ENGINE - AIR - INTRODUCE A NEW LPC BLEED MASTER ACTUATOR FEATURING A LINEAR VARIABLE DIFFERENTIAL TRANSFORMER (LVDT) WITH IMPROVED WIRE TERMINATION - CATEGORY CODE 4, 7 - MOD.ENG-75-0041

ENGINE COMPRESSOR CONTROL - LPC BLEED -
MASTER ACTUATOR - INTRODUCTION OF
LINEAR VARIABLE DIFFERENTIAL TRANSFORMER
(LVDT), WITH IMPROVED WIRE TERMINATION

(IAE SB V2500-ENG-75-041, Revision 1)
(LUCAS ENGINE SYSTEMS MOD. D.TV.050)

LVDT Output Voltage Checks
Figure 2

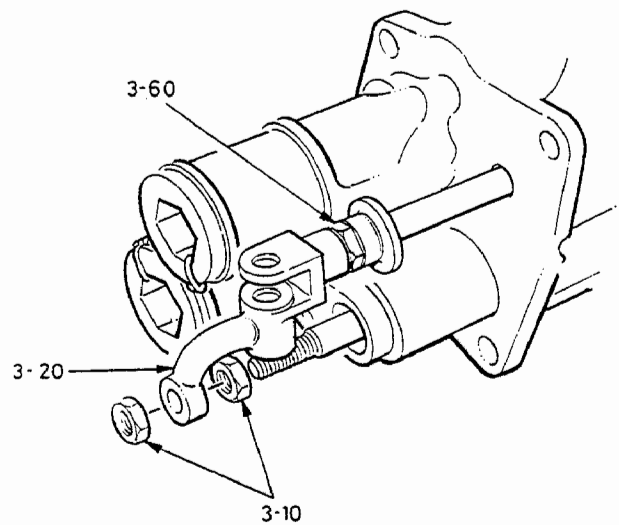
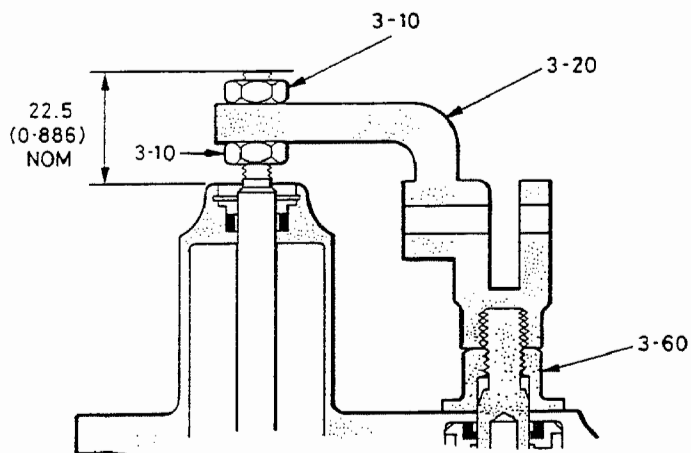
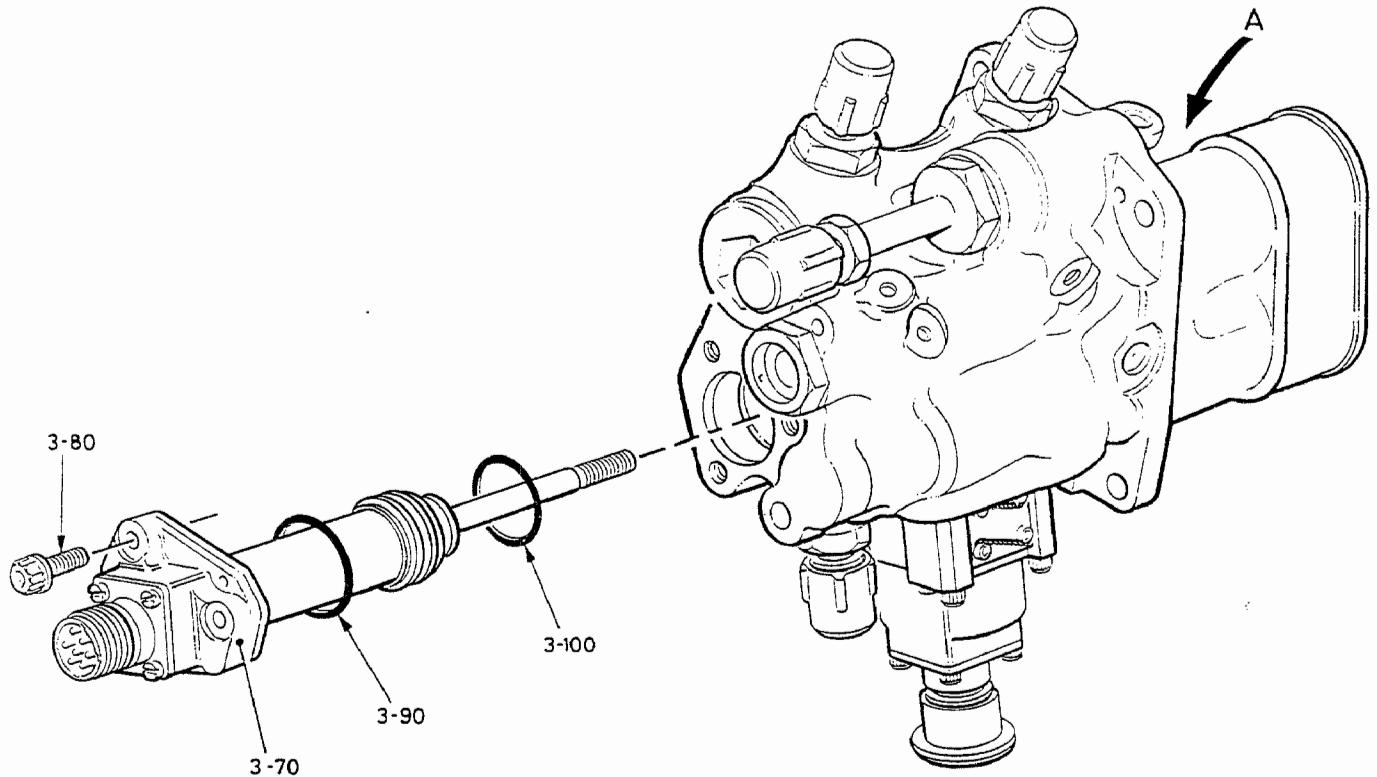
- (5) Check the local electrical supply voltage (120v or 240v). Refer to Figure 2 and set the voltage selector switch on the LVDT indicator unit EL4049, to equal the supply voltage. Connect the indicator unit to the mains supply and switch the on/off switch to the ON (down) position.
- (6) Set the winding selector switch to the PRIMARY position and adjust the energising voltage to $6.000 \pm 0.005\text{v}$ by means of the 6v adjustment potentiometer on the front panel of the indicator unit.

- (9) Check the LVDT Adjustment, Figure 2.
- (a) Connect the cable assembly to the socket on the LVDT indicator unit (EL4049), and the LVDT connector on the Actuator unit.

- (i) Remove the slip gage and move the ram piston (3-170) (by hand) to the fully extended position. Check the LVDT output voltages (Channel 1 and Channel 2), at this position; both voltages must be within the limit of 0.470 to 0.584v.

Removal and Installation of the LVDT
Figure 1

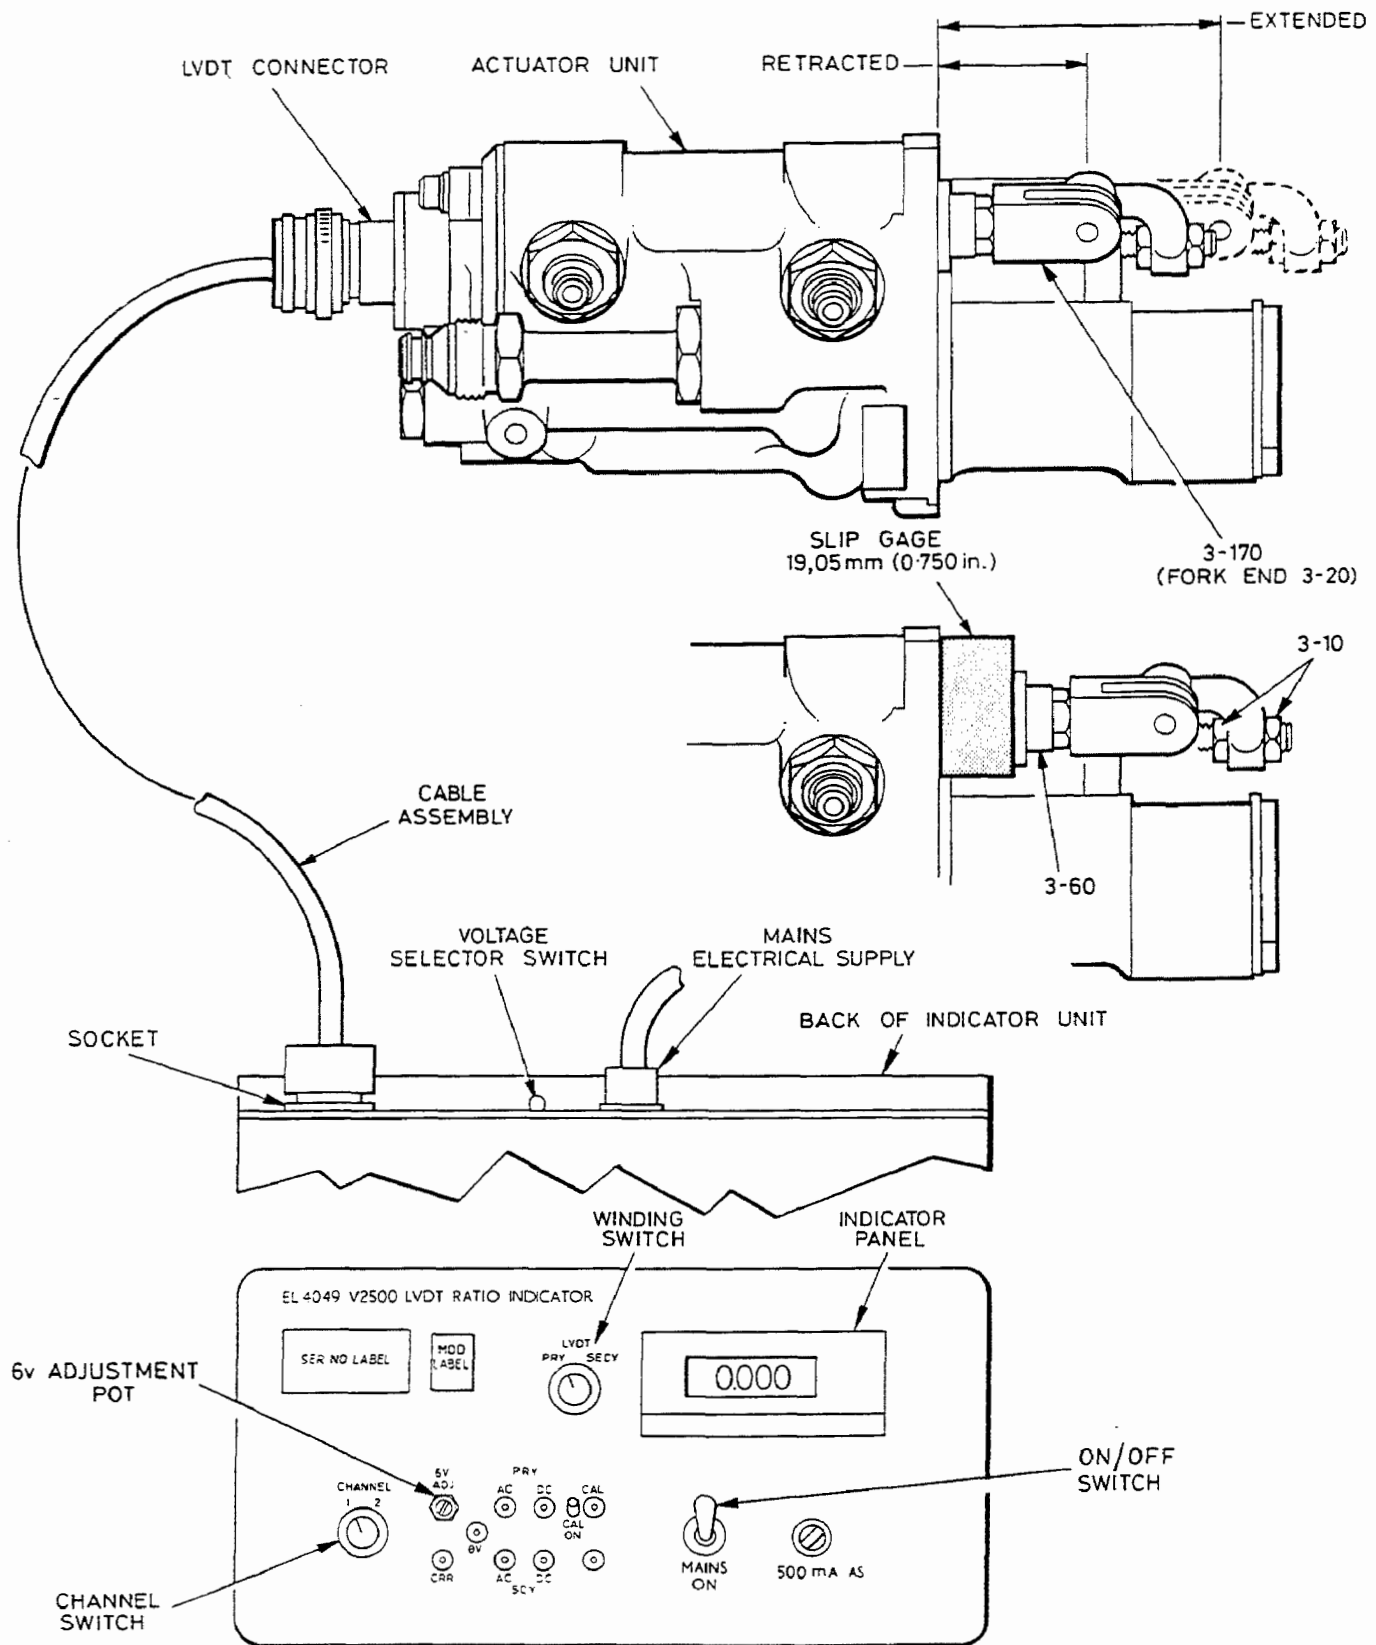
- (7) Remove the LVDT, Figure 1.
 - (a) Extend the actuator jack piston (3-170) by hand to approximately the mid-stroke position.
 - (b) Remove the lockwire and slacken the two locknuts (3-10) which secure the stem of the LVDT (3-70) to the fork end (3-20). Remove the outer locknut (3-10) completely.
 - (c) Remove the three machine bolts (3-80) which secure the LVDT flange to the actuator body. Withdraw the LVDT until the stem of the LVDT is clear of the fork end (3-20) and remove the second (inner), locknut (3-10) from the LVDT stem; remove the LVDT from the actuator body.
 - (d) Remove the toroidal sealing rings (3-90) and (3-100) from the LVDT; discard the sealing rings.
 - (e) Attach a label to the removed LVDT; the label must contain this data:

- (8) Install the Replacement LVDT, Figure 1.
 - (a) Carefully remove the replacement LVDT (1777-4000) from the protective package. Make sure that the Supplier's Certificate is with the LVDT; make sure also that the Serial Number on the Certificate is the same as that on the flange of the LVDT.

- (c) Remove the LVDT (1777-4000) from the polythene bag and clean all the surfaces with a dry, lint-free cloth.
 - (d) Get the replacement toroidal sealing rings STD831-13, (3-90) and STD831-7, (3-100); remove the sealing rings from the protective packages and assemble them to the LVDT. Make sure the seals are not twisted in the grooves.

- (f) Align the three holes in the flange of the LVDT with the three holes in the actuator body and assemble the three machine bolts (3-80).
 - (g) Check, when the machine bolts are tightened, that there is a minimum of 0,23 Nm (2 lbf.in.) inbuilt torque in each of the inserts. If the inbuilt torque is less than this figure, reject the unit for Repair. Torque tighten the machine bolts to 4,5 Nm (40 lbf.in.).

- (h) Move the jack piston (by hand) to the fully retracted position (with the flanged nut (3-60) in contact with the face of the actuator body). By adjustment of the two lock nuts (3-10), set the stem of the LVDT to the dimension shown in Figure 1; use a vernier calliper or depth gage to measure the standout. Tighten the lock nuts (3-10), hand tight only.
